DOCUMENT CHANGE NOTICE (DCN)

DOCUMENT No. (DOC-REV-GP. ID)	TITLE	NEW REV.
D 960045 A	BEAM TUBE Baffle, Full Section, FAB & Porcelain Coverage Detail	B
D 960046 A	" " " NON SERATED " " " "	B

REASON FOR CHANGE: Tooling Requirements & Revising of tolerancing

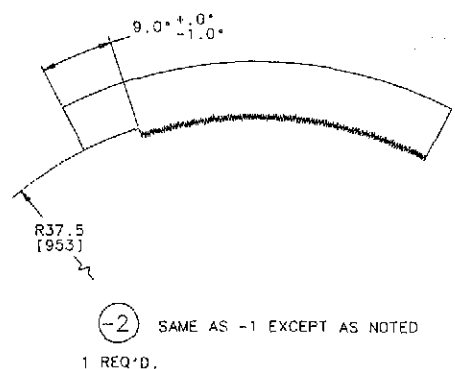
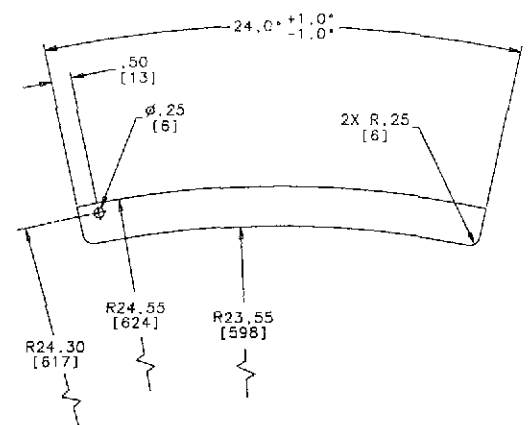
CHANGE DESCRIPTION (FROM/TO): Add HOLES for Tooling for INSTALATION of Porcelain Application
 Changed tol. on detail ①, ② & TAB. Angle Detail ②

DETAIL B

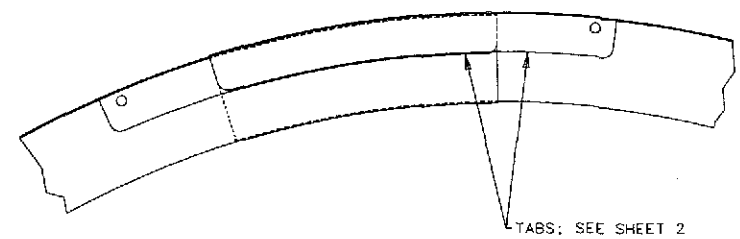
• TOP SURFACE OF CONE SEGMENT BUTT JOINTS TO BE FREE OF WELD MELT-THROUGH. EDGE MISMATCH NOT TO EXCEED .010 (.25).
 ALT 2 RATHER THAN 4 SEGMENTS.
